Computer Monitors Service Bulletin

CSI-111

Model: GDM17SE1, GDM20SE1

Subject: D824 Improvement

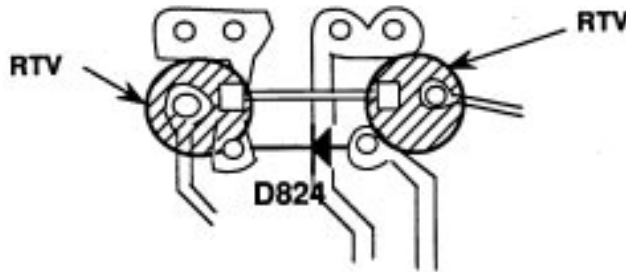
Solution: Please check D-824 on the D-Board. If shorted, replace as follows:

1. Replace D824 with a 1SS83 type

2. Apply RTV to locations illustrated below:
